Lone Tree City Council Agenda Tuesday, April 5, 2016

Project Type / #: Preliminary Plan, Project SB16-12R

SUBJECT: RidgeGate Section 22, Filing 1, Preliminary Plan
(Also known as Tract GG or The Retreat at RidgeGate)
Project SB16-12R

RIDGEGATE - SECTION 22, FILING NO. 1
 PRELIMINARY PLAN
 TITLE SHEET

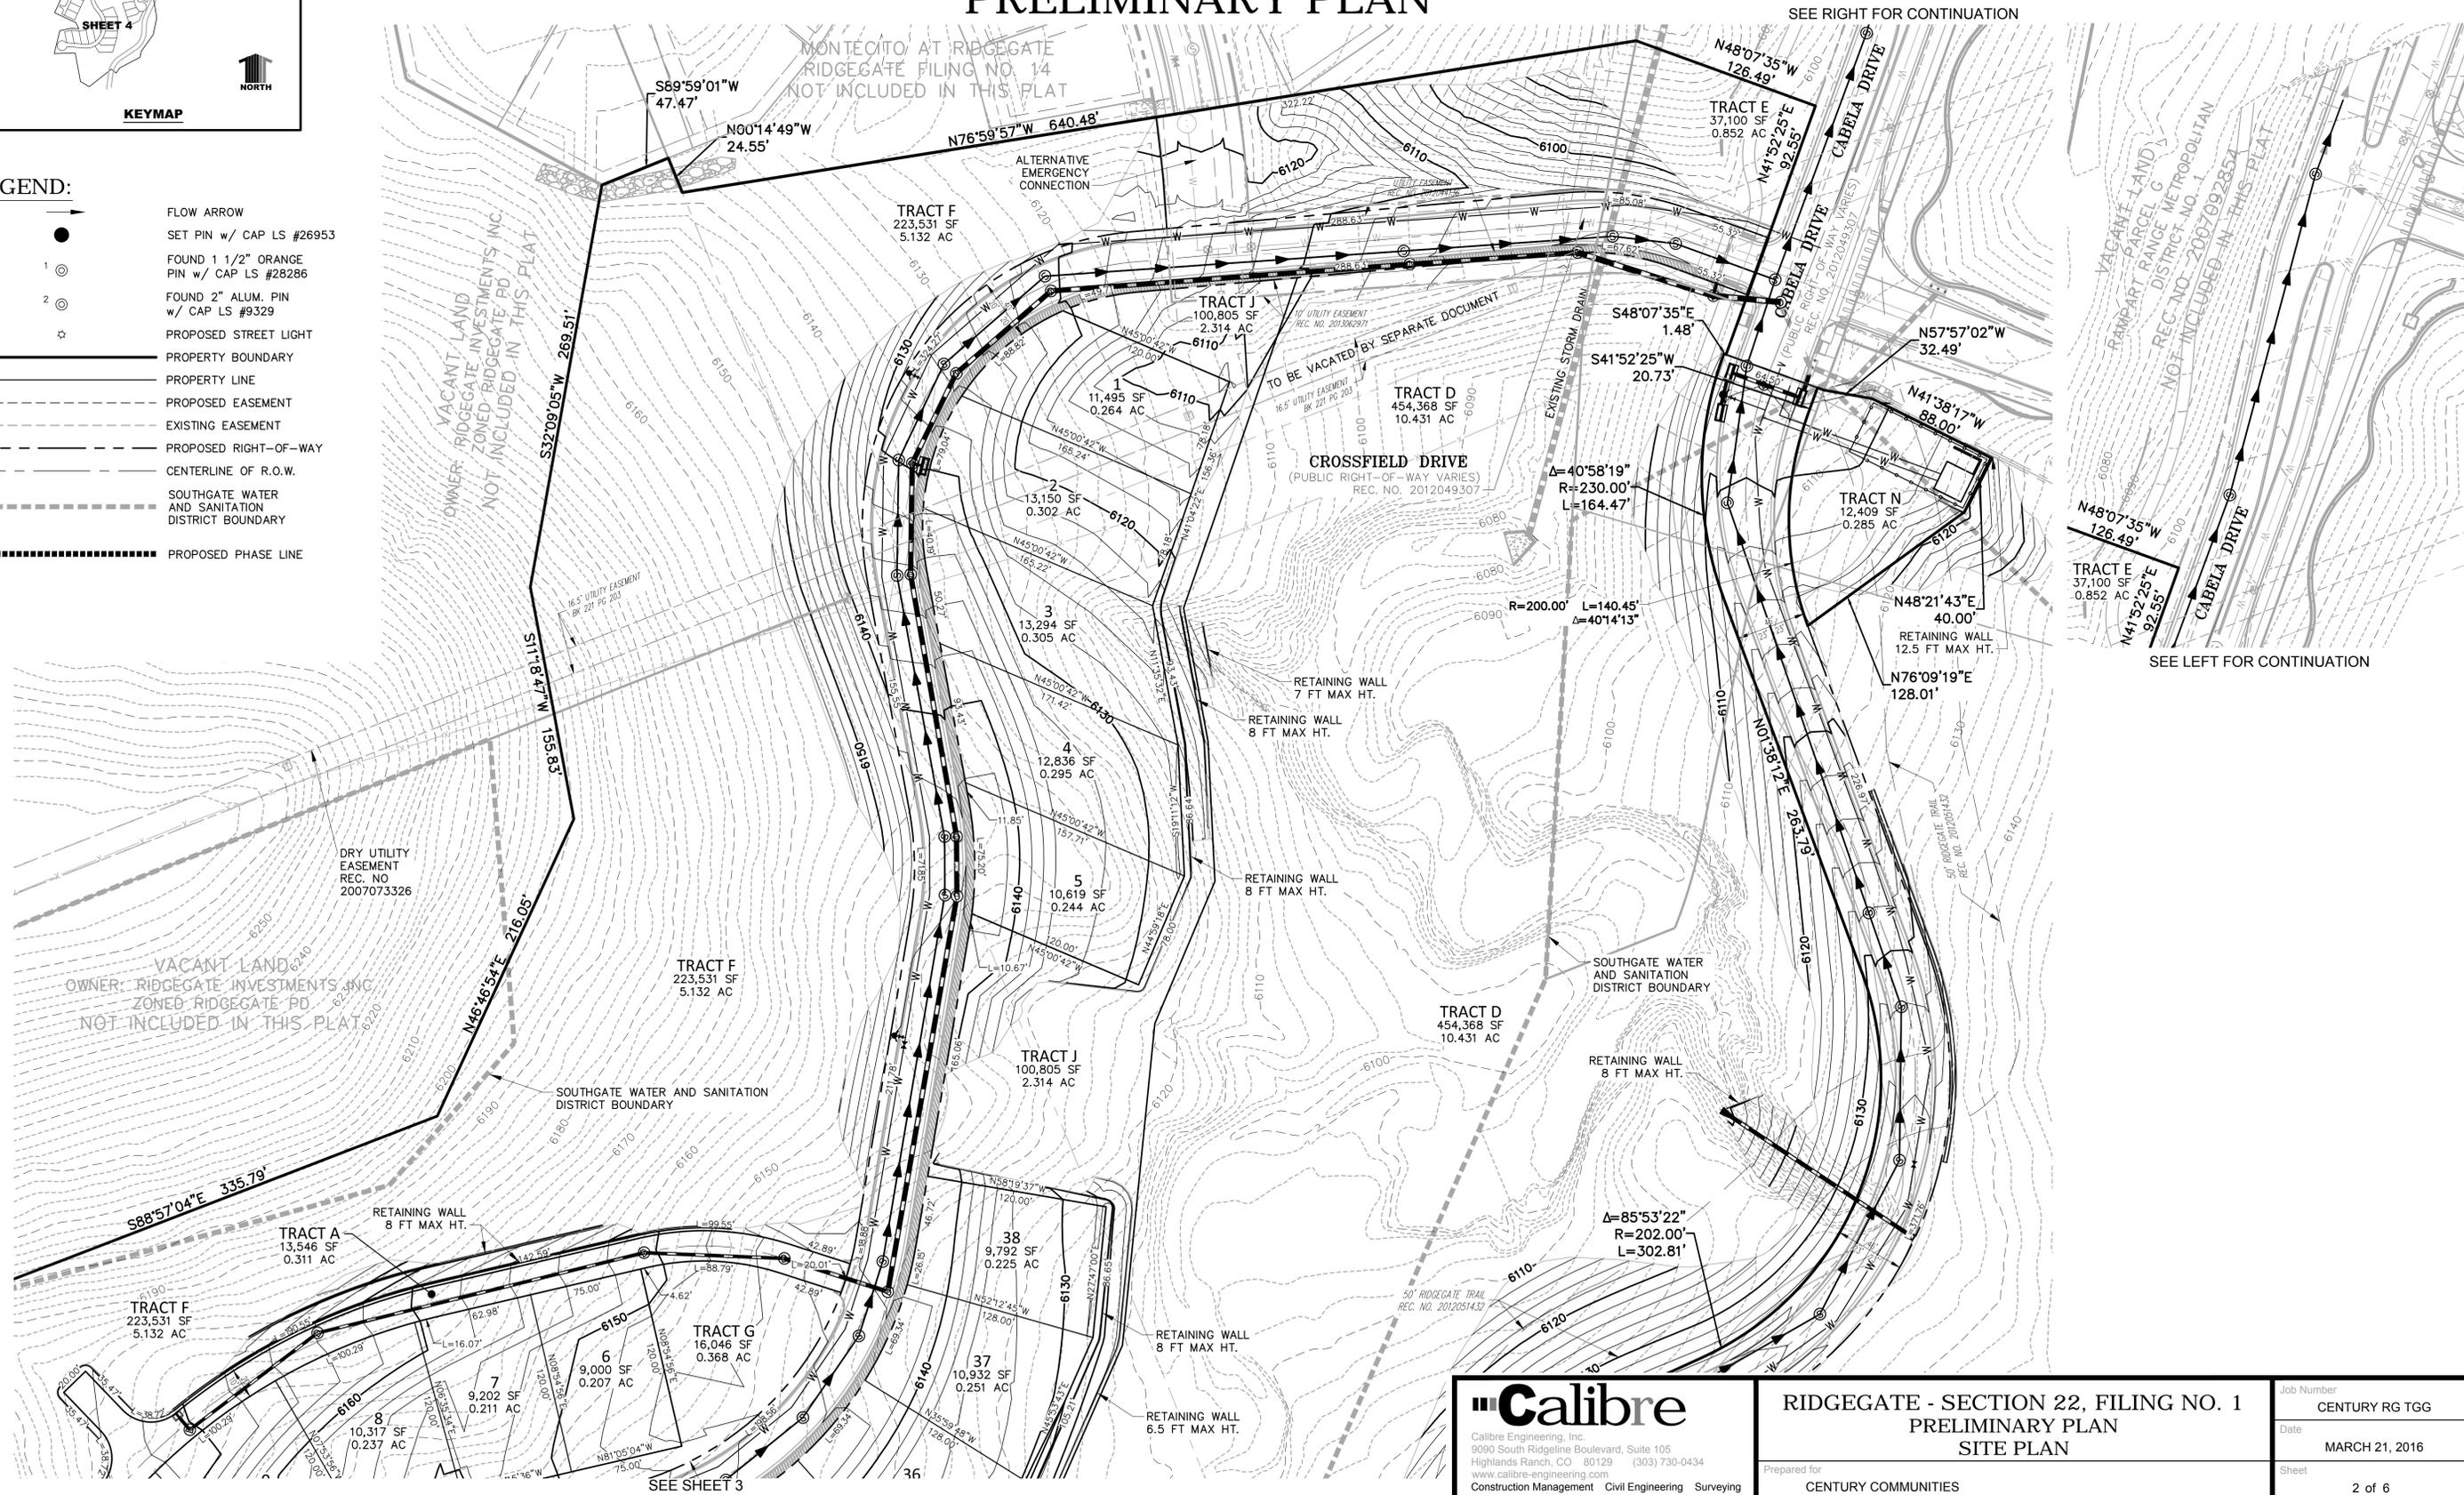
Sheet 1 - Title Sheet

2. We recommend the Section Lines and applicable labels (Section 5 & Section 22) be clearly shown on the documents, including the Vicinity Maps on Sheet 1, as well as the rest of the plan sheets as applicable.
Response: Section lines have been added to the Vicinity map and remain shown throughout the Preliminary Plan.

RIDGEGATE - SECTION 22, FILING NO. 1
 PRELIMINARY PLAN
 EXISTING SLOPE ANALYSIS

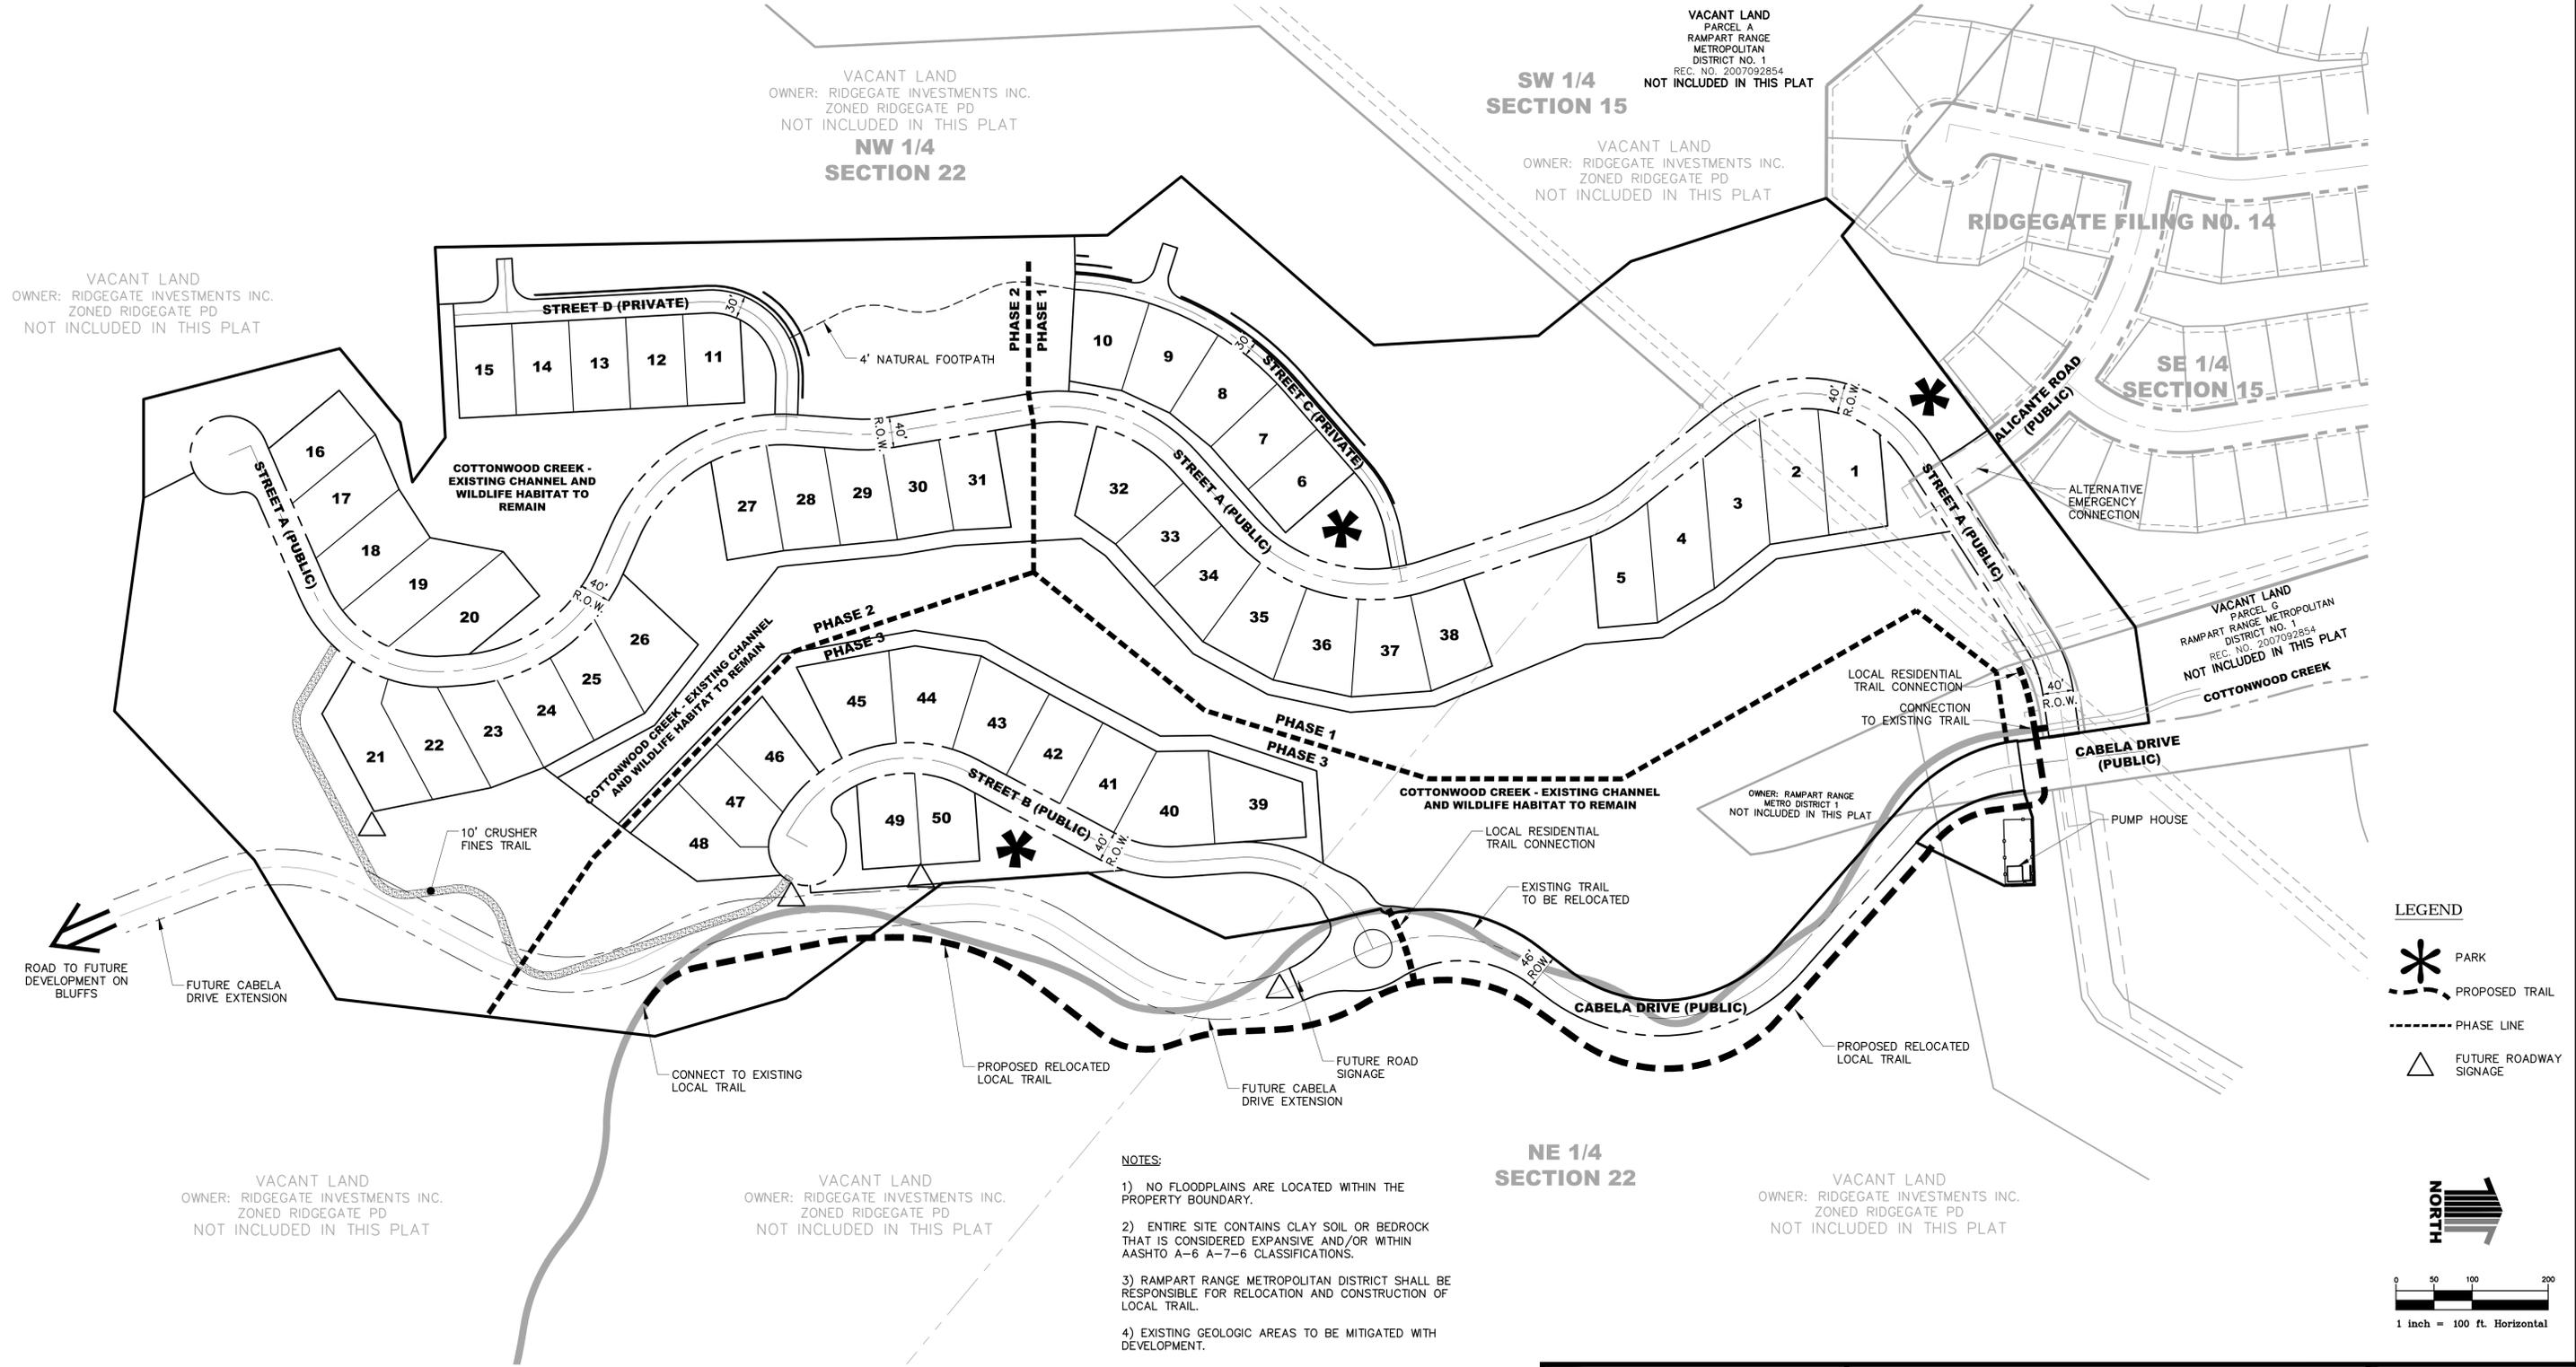
6. General Note #4 references the Geologic Hazard Areas Plan on Sheet 6. The correct reference should be to Sheet 5.
